**DOCKETED**

# **San Jose' City Data Center (19-SPPE-04)**

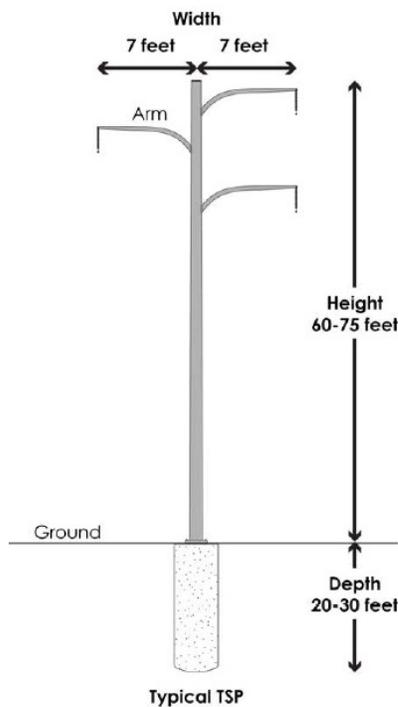
**Response:** The Applicant will consult with PG&E to determine if additional information is available at this time and will update/docket Figure 2-6 when additional information is provided.

**Response:** The Applicant will consult with PG&E to determine if additional information is available at this time.

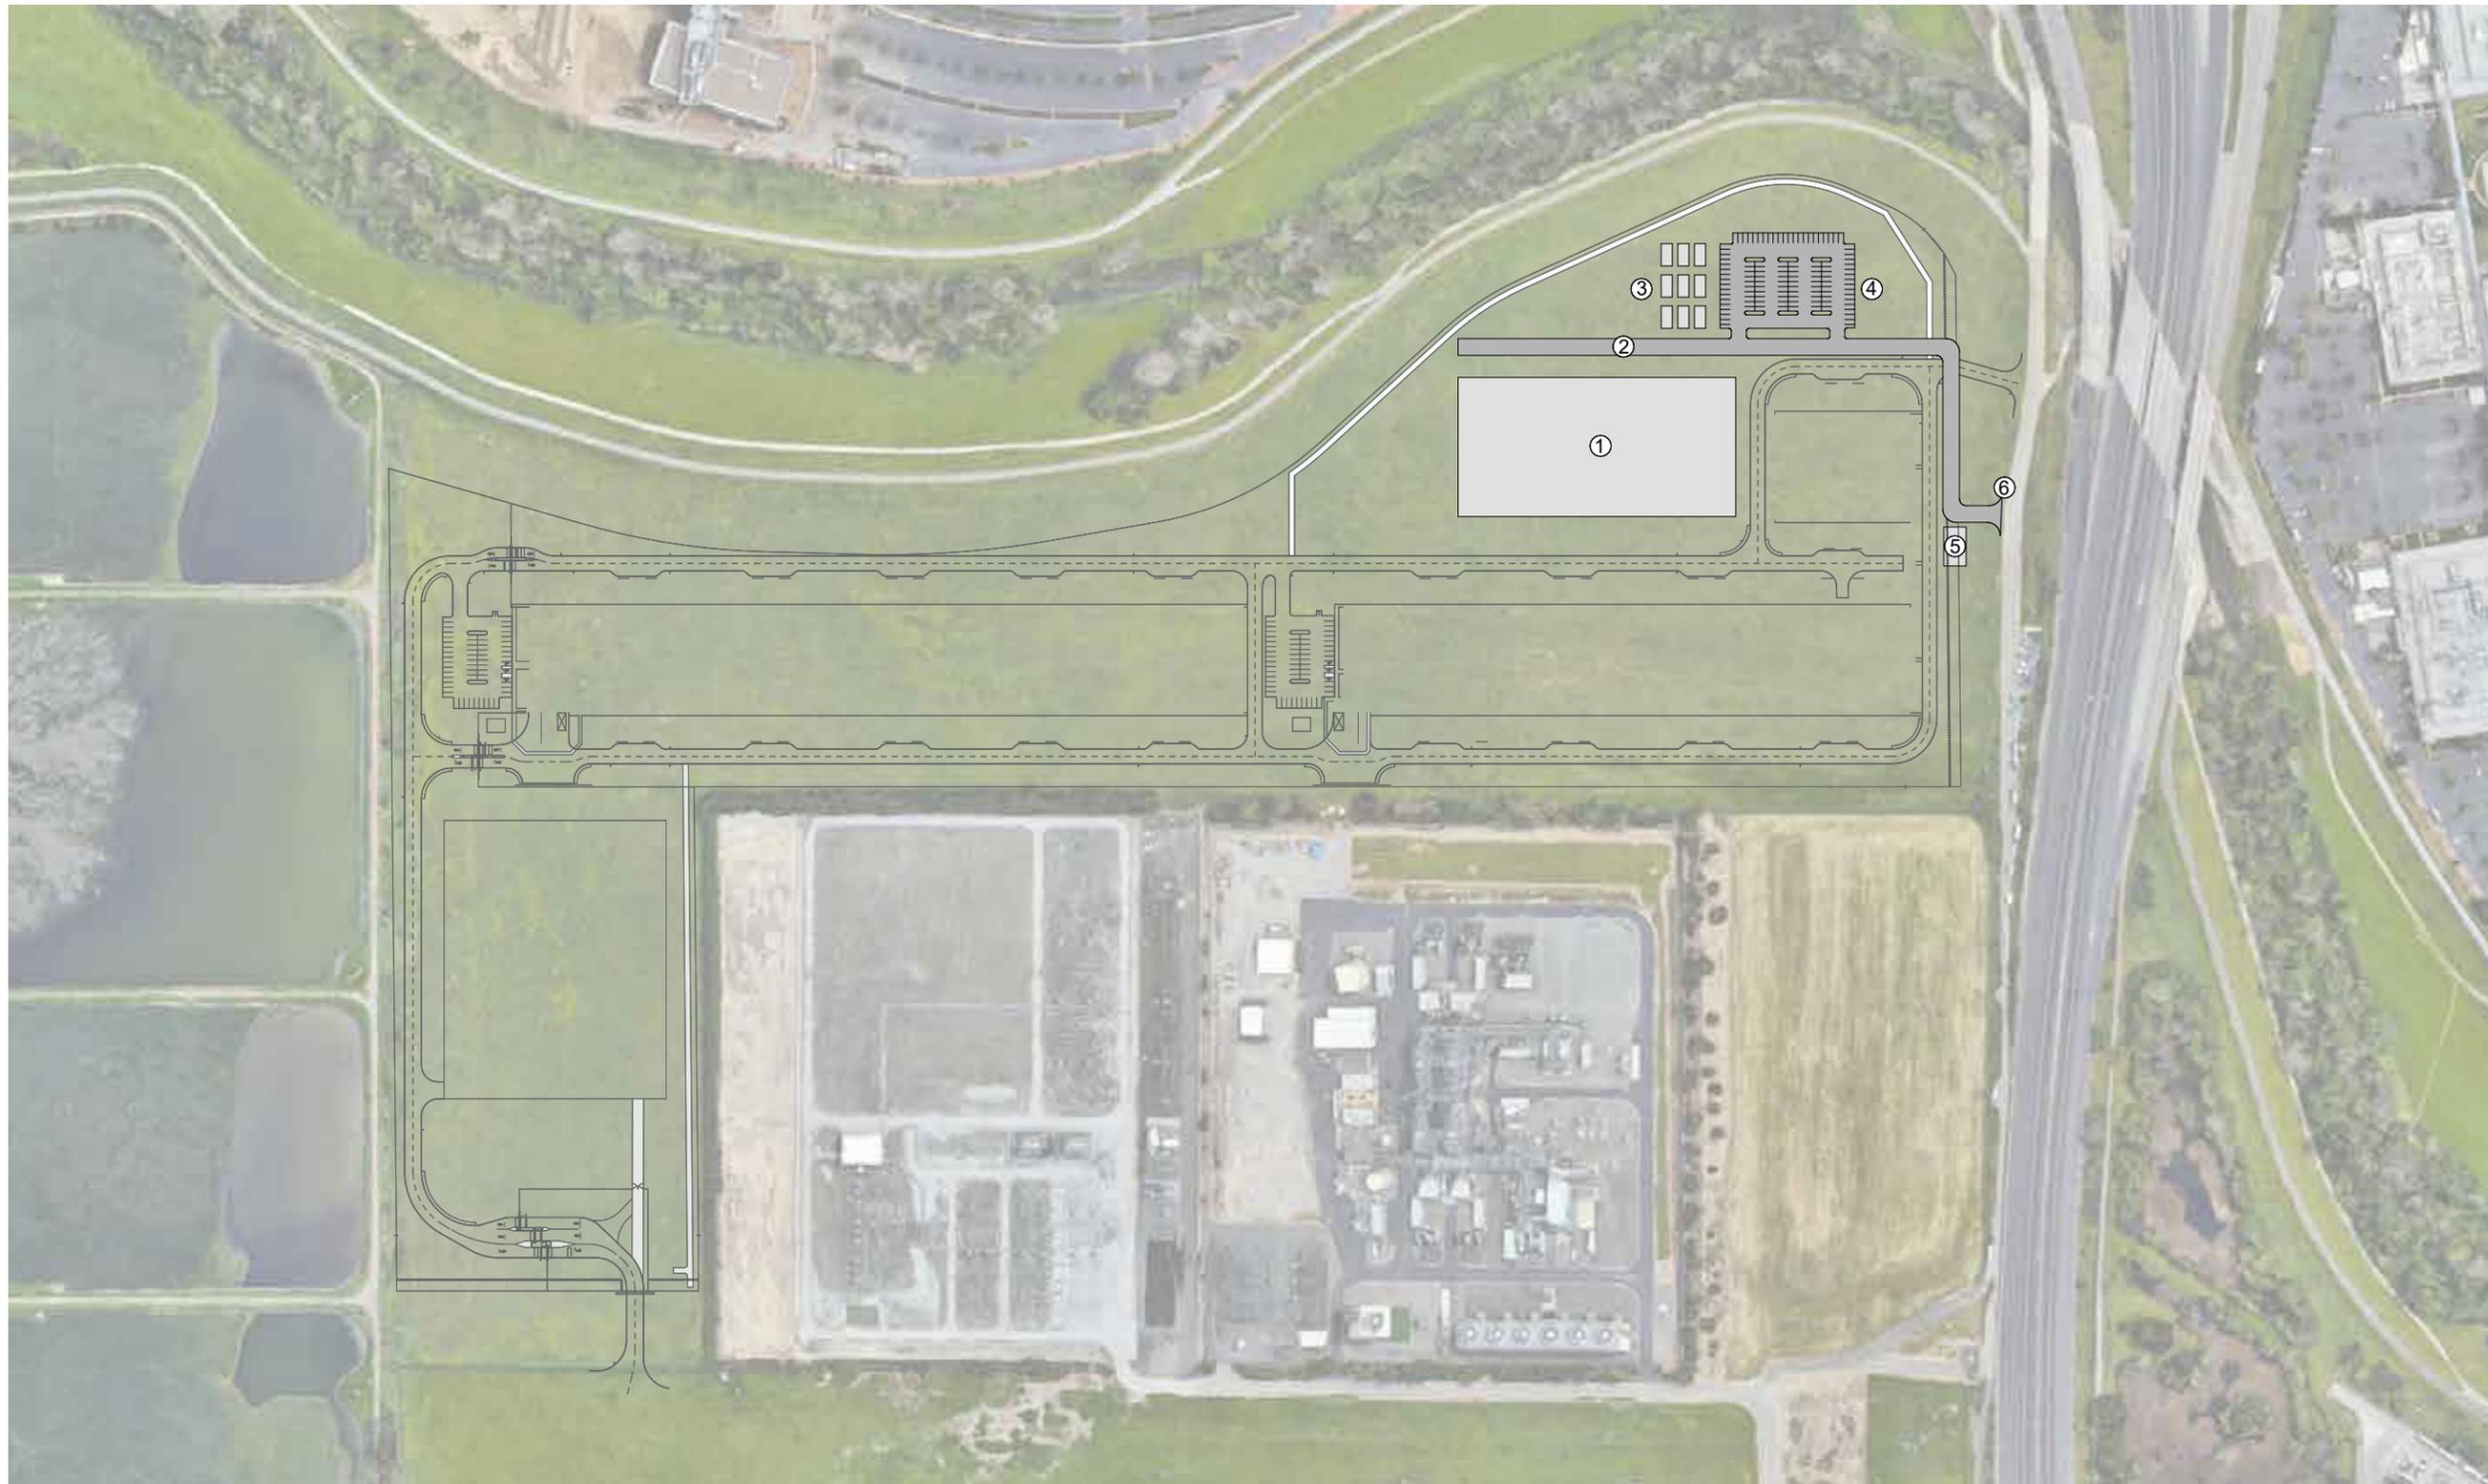
**Response:** No, a site visit was not conducted with the Northern Valley Yokuts Tribe. We informed the tribe of the CEC's role as the CEQA lead agency and Assembly Bill 52's requirements for tribal consultation in this regard.
